APPENDIX 3

PHOTOGRPHS OF MODIFICATION

View of Panel

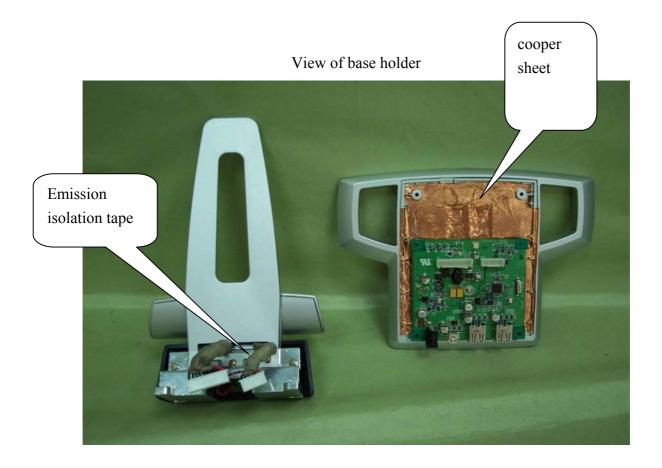
- 1. One cooper sheet provides at base holder, see photo for details.
- 2. Emission isolation tape provides at signal cables, see photos for details.
